Date: [Nov. 2009]

PCN No.: [120]

## PRODUCT CHANGE NOTIFICATION, XPort 04

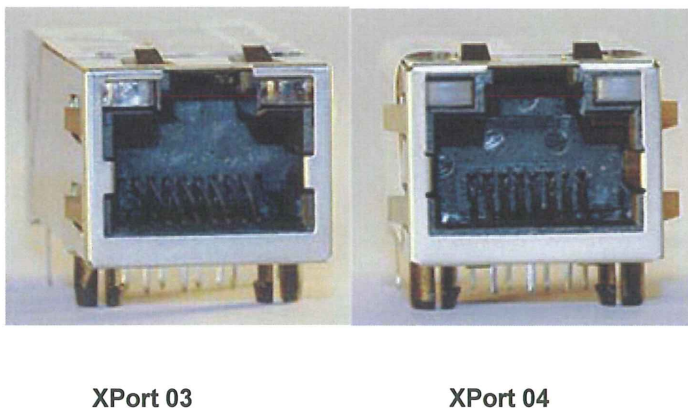
1. The number of spacers at the base of the XPort 04 were increased from 1 to 3 to add more placement stability. The height of the spacers remain the same.
